**CALIFORNIA COASTAL COMMISSION**

### STAFF REPORT: REGULAR CALENDAR

**APPLICATION NO.:** 4-01-235

**PROJECT DESCRIPTION:** Construction of a two story, 35 foot high, 7,537 sq. ft. single family residence, with two garages (one attached and one detached), driveway, turnaround, 750 sq. ft. guest house, swimming pool and spa, stairs, gazebo, septic system, and approximately 3,400 cu. yds. of grading (1,700 cu. yds. cut, 1,700 cu. yds. fill).

EXHIBIT NO. 2

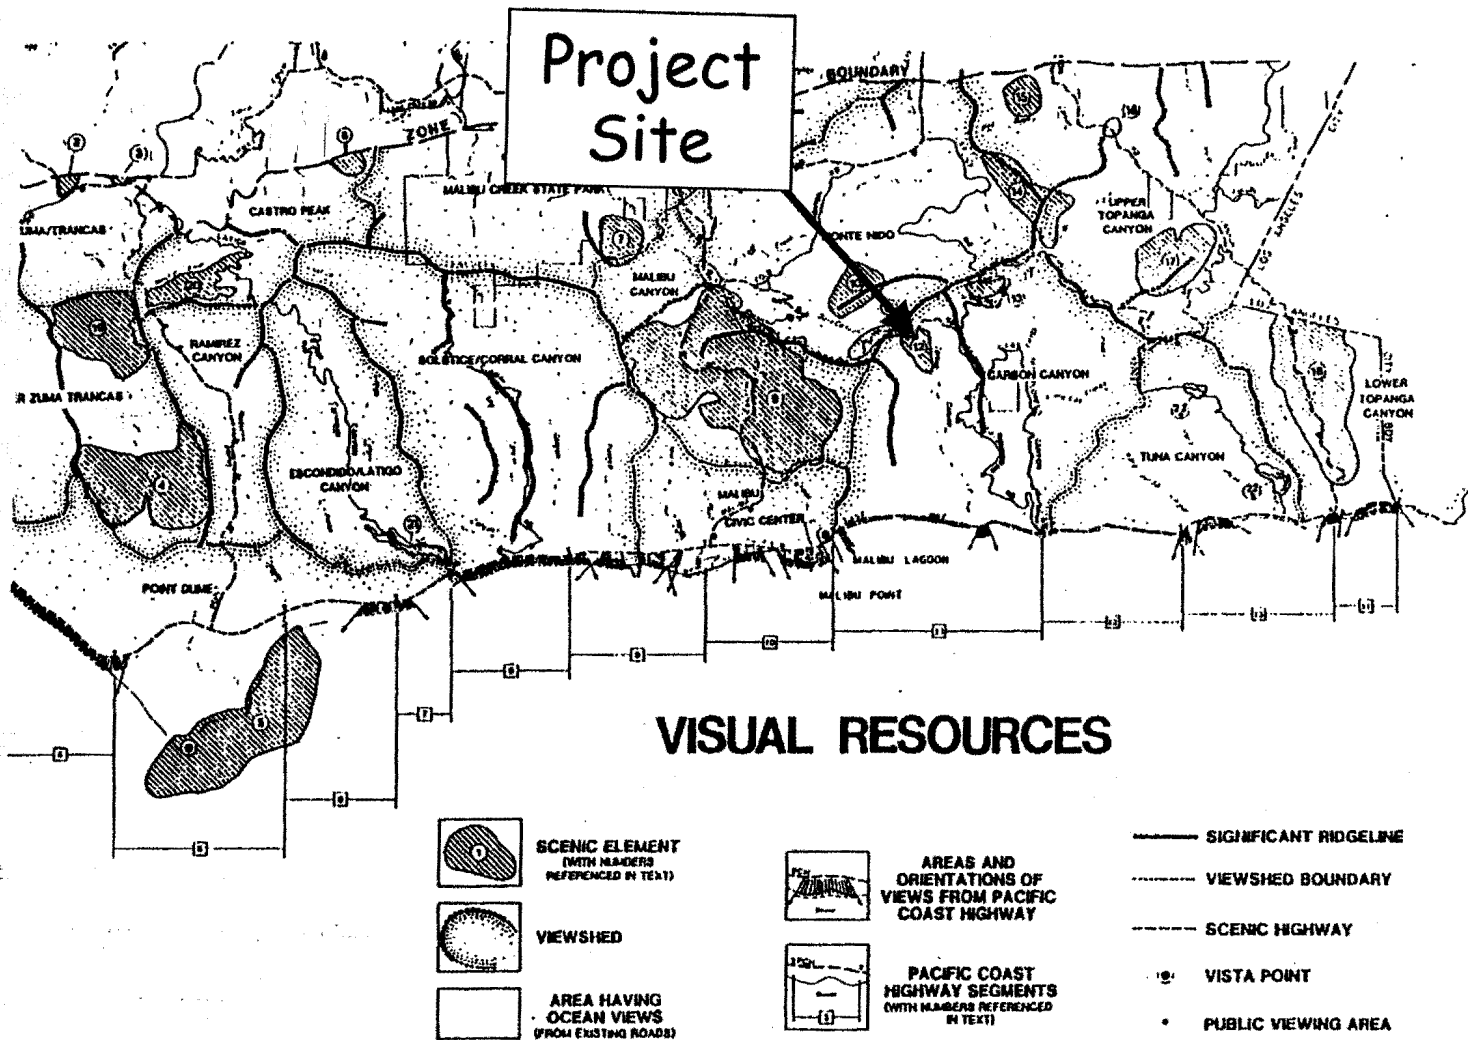
vegetation. The project site is visible from public viewing areas along Rambla Pacifico, Pioma Road, and the Saddle Peak Trail (which runs along Pioma Road) and is located within a scenic element identified in the Commission-certified 1986 Malibu-Santa Monica Mountains Land Use Plan (LUP). The project site is also visible, in the far distance, from Pacific Coast Highway, approximately two miles south of the project site (Exhibits 2 and 14).

EXHIBIT NO. 9
APPLICATION NO.
4-01-235
GRADING DETAIL

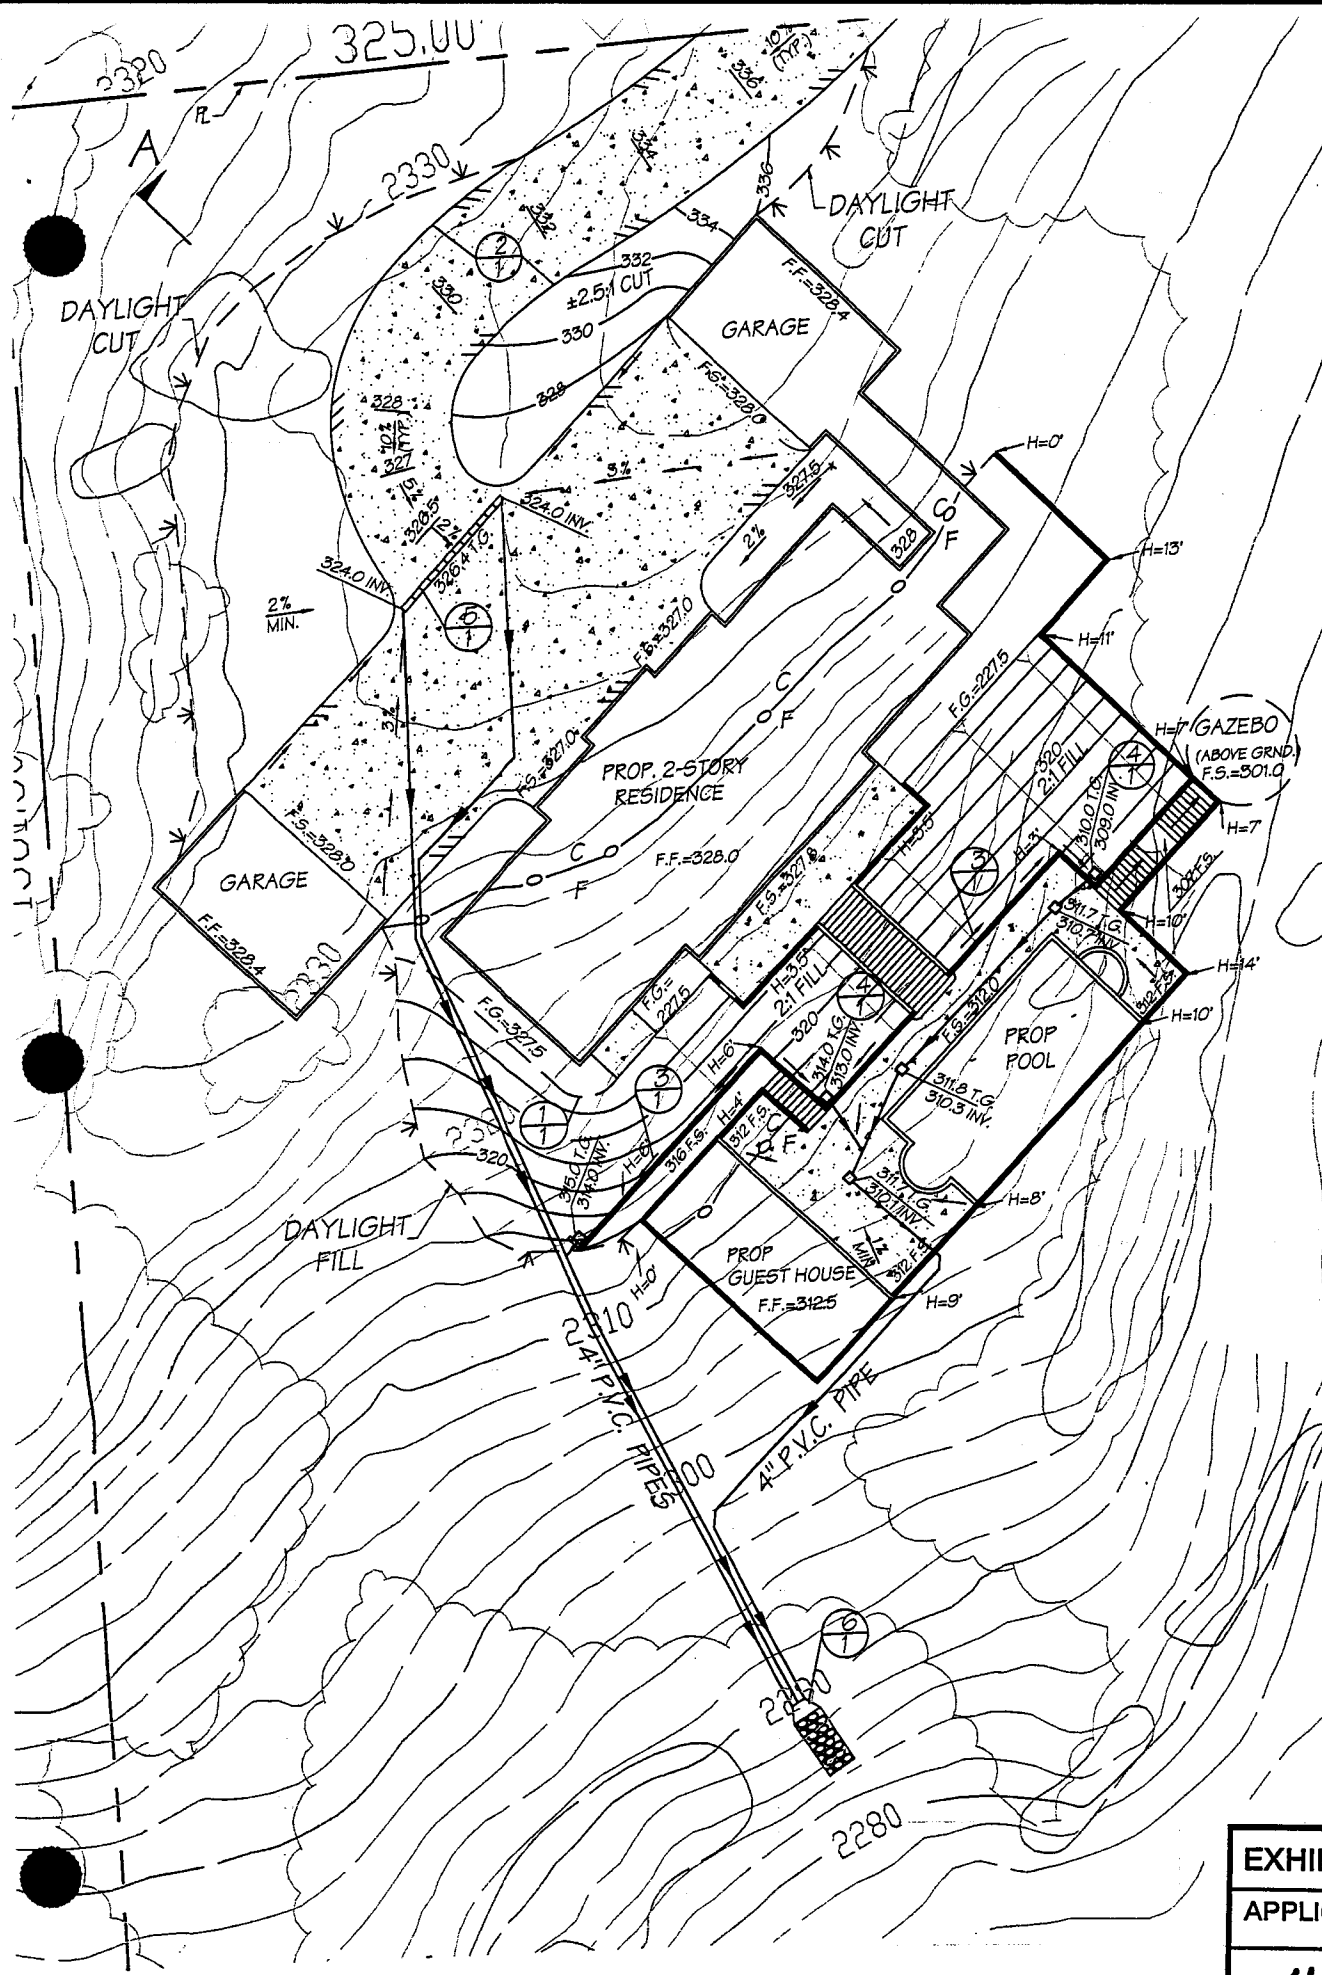
In summary, the proposed development would result in the creation of three level pads supported by retaining walls (for the turnaround/garages, main residence, and swimming pool/guest house areas respectively) and a 2:1 fill slope in a development area covering approximately 18,000 sq. ft. of hillside. The siting and design of the proposed project would result in significant landform alteration, inconsistent with Section 30251 of the Coastal Act.

Several revisions or alternatives to the proposed project are feasible that would significantly minimize landform alteration, while still allowing for a reasonable size, bulk and scale of residential development to occur. These alternatives include multiple combinations of the following: (a) reduction in the size, bulk and scale of the structures, (b) use of a split-level design which follows the natural topography of the site rather than the proposed design which elevates the main residence and lower swimming pool/guest house area on fill; and (c) deletion of the guest house, swimming pool, gazebo, and second garage. These alternatives are discussed further in Subsection 4 below.

EXHIBIT NO. 10
APPLICATION NO.
4-01-235
GRADING X-SECTION

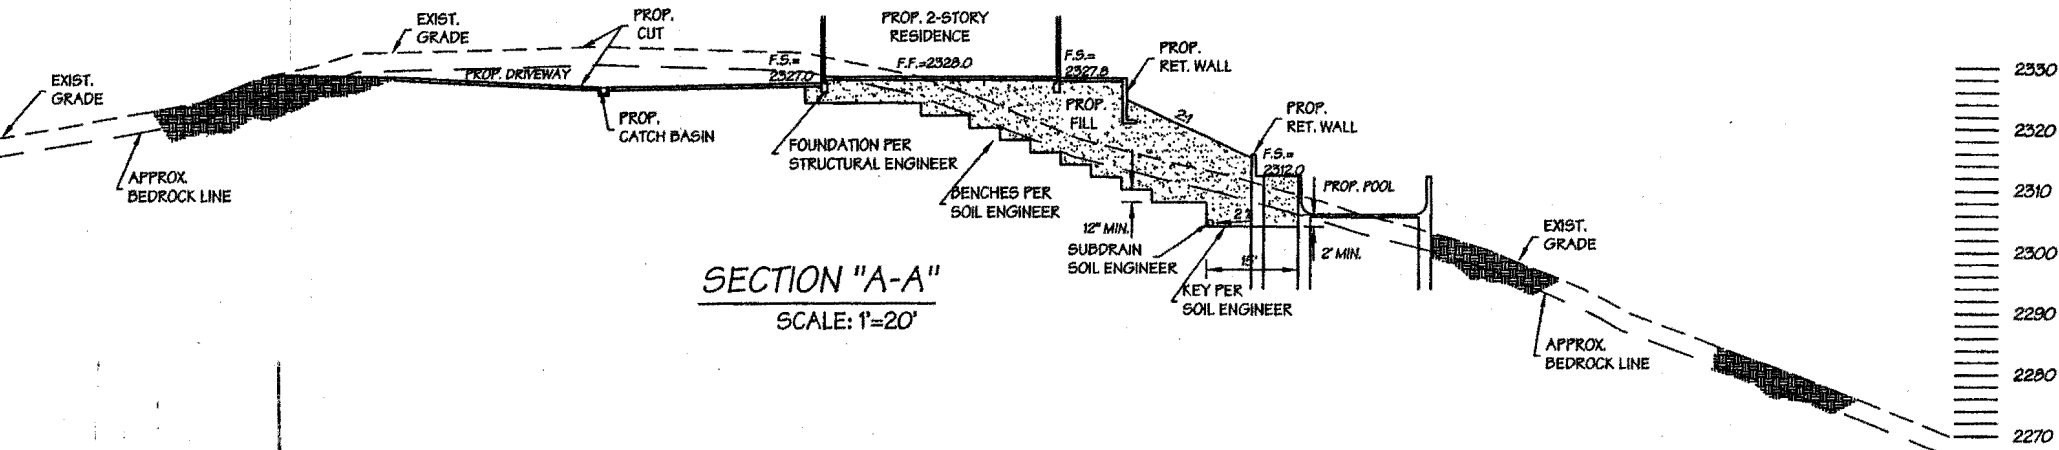
As proposed, the main residence would be constructed on a level grade achieved by cutting into a portion of the slope just below the crest and placing a wedge of fill up to 14 feet in height on the lower portion of the slope. The applicants propose to construct a 2:1 fill slope between the swimming pool area and the main residence, and to construct the proposed swimming pool and guesthouse on an additional wedge of fill. The applicants propose to support the areas of fill with several retaining walls ranging from 0 to 14 feet in height.

As proposed, the main residence would be constructed on a level grade achieved by cutting into a portion of the slope just below the crest and placing a wedge of fill up to 14 feet in height on the lower portion of the slope. The applicants propose to construct a 2:1 fill slope between the swimming pool area and the main residence, and to construct the proposed swimming pool and guesthouse on an additional wedge of fill. The applicants propose to support the areas of fill with several retaining walls ranging from 0 to 14 feet in height. The proposed project includes 3,400 cu. yds. of grading (1,700 cu. yds. cut, 1,700 cu. yds. fill).

The proposed project includes a substantial amount of grading to create three level pad areas and a connecting 2:1 slope on the site. In addition to reducing the size, bulk and scale of the structures a multiple split level design could reduce grading and minimize visibility of the development. The Commission notes that the use of a multiple split-level design (the use of several small pads cut into the slope) would eliminate the need for large uniform level pad areas and prominent retaining walls and would minimize landform alteration, while allowing the development to conform to the natural topography of the site.

**EXHIBIT NO. 12**  
**APPLICATION NO.**  
**4-01-235**  
**BRUSH CLEARANCE**

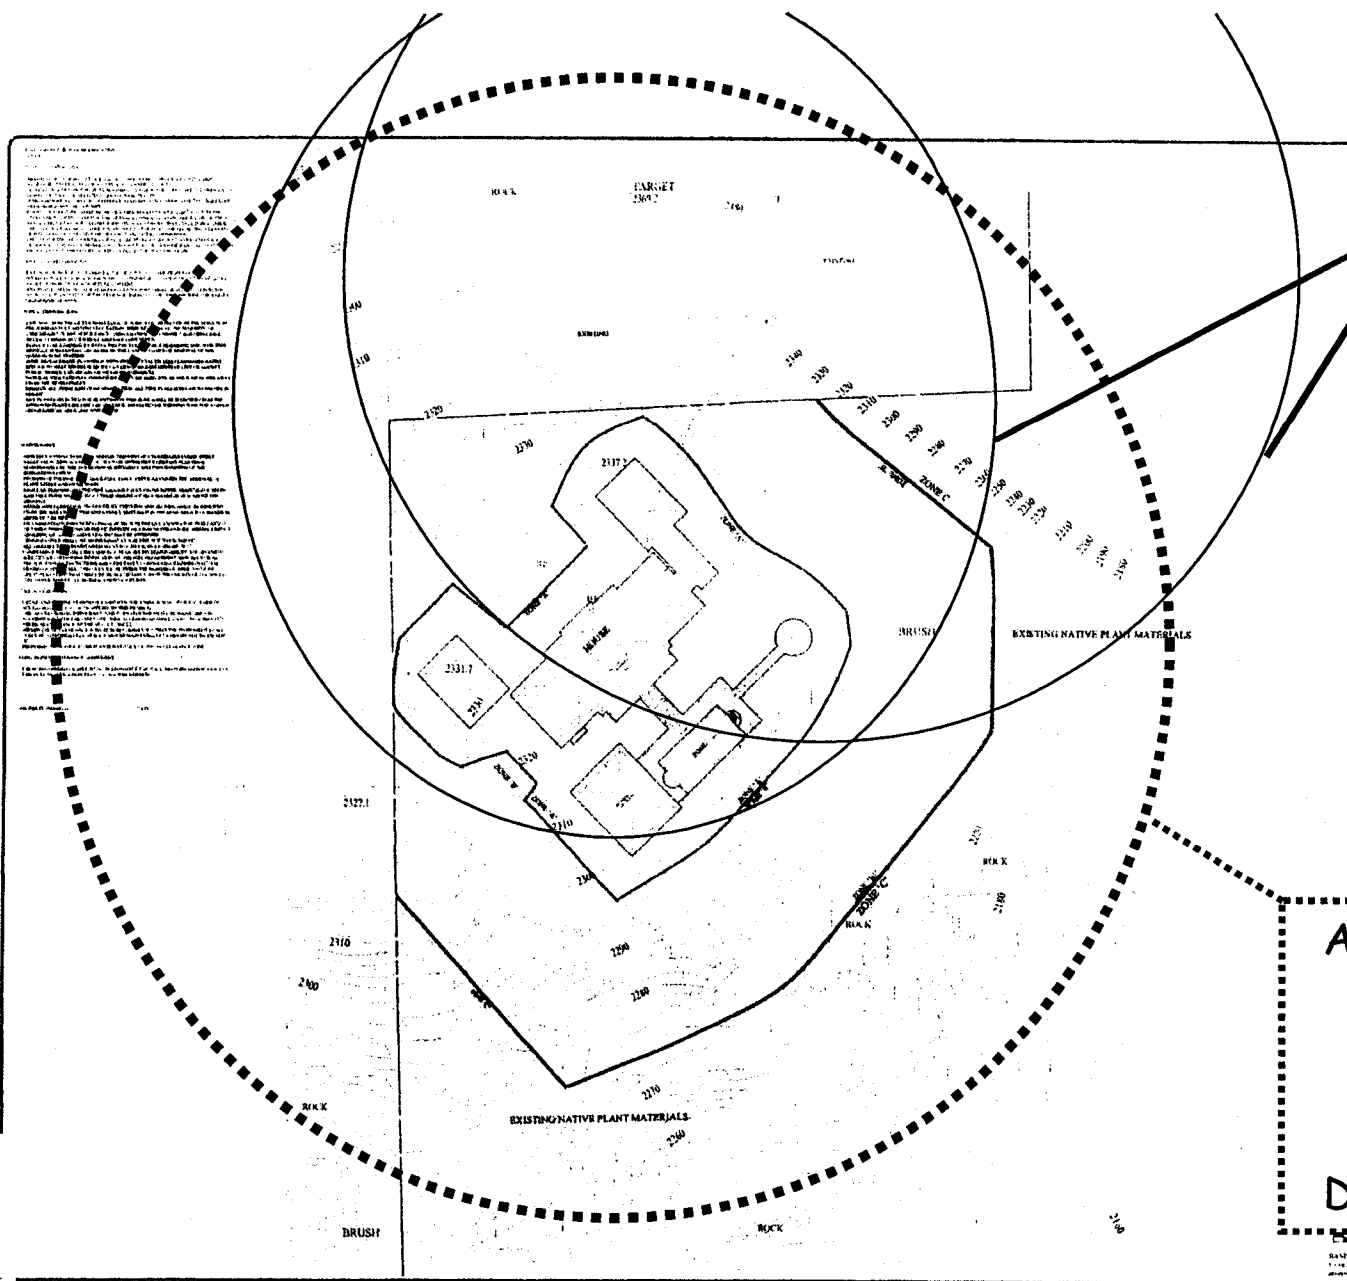
The project site is surrounded on three sides by undeveloped hillside. Several single family residences are located along the ridgeline to the north of the project site. The proposed project will extend the brush clearance radius up to 200 feet down steep slopes containing native coastal sage scrub vegetation (Exhibit 12).

The proposed project ~~would extend the brush clearance radius~~ up to 200 feet down these steep slopes and result in the clearing of native coastal sage scrub vegetation. The proposed project would also result in the implementation of a fuel modification regime that would introduce irrigated, non-native plants onto the hillside and adjacent graded areas. The irrigated fuel modification zones would extend 100 feet down the hillside, and would include areas of native vegetation on slopes ranging from near vertical (northeast and east of the proposed development) to 4:1 (south of the proposed development). Approximately half of the irrigated area would be on slopes with gradients less than 1.5:1. In addition, Fuel Modification Zone C, which would extend an additional 100 feet down the slope would result in the implementation of thinning requirements, including the removal of native coastal sage scrub species including chamise, buckwheat and several varieties of sage. In summary, the proposed project would result in significant clearing and irrigation of much of the steep slope below the project site.

The proposed project includes the construction of a large terrace or patio area with a pool, guest house and gazebo in front of and below the proposed main residence. The project also includes the construction of a second garage immediately southwest of the main residence. Construction of these amenities are not necessary in order to allow for residential development to occur on the subject site. Deletion of the guesthouse and gazebo from project plans would reduce the irrigated fuel modification radius by approximately 50 feet. Deletion of the second garage would reduce the irrigated fuel modification radius west of the main residence, and, more significantly, reduce the brush clearance radius up to 50 feet on the steep slopes of the adjacent undeveloped property.
